Port Street, Manchester, UK

PURPOSE OF THE REPORT

This document has been prepared as working record of the visual inspection of the samples explored for Port Street - ref132489/FO/2021 (with relevant conditions as amended by 135938/NMC/2023) - in accordance with the Hand Sized Samples Programme 24.11.2022 submitted to MCC as part of Condition 4a.

MORTAR COLOUR AND POINTING EXPLORATION

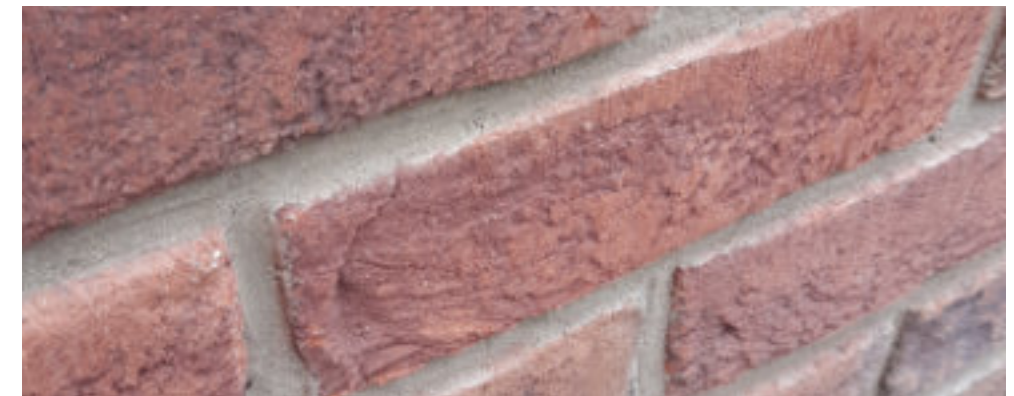
Light brown mortar - bucket handle. Colour mortar too light for the desired design intent. Pointing not suitable for the brick texture

Buff mortar - bucket handle. Colour not suitable for the desired design intent

Red mortar - weather struck. Colour too light for the desired design intent. Pointing not suitable for the brick texture

Natural colour mortar - 2mm recess. Pointing highlights brick sharp finish. Colour not suitable for desired design intent

Dark brown mortar - 2 mm recess . Colour matches brick tone. Pointing keeps a clean edge in an otherwise rough brick texture. [Selected option](#)

White mortar- 2 mm recess - Pointing highlights brick sharp finish. Colour matches with brick tone. [Selected option](#)
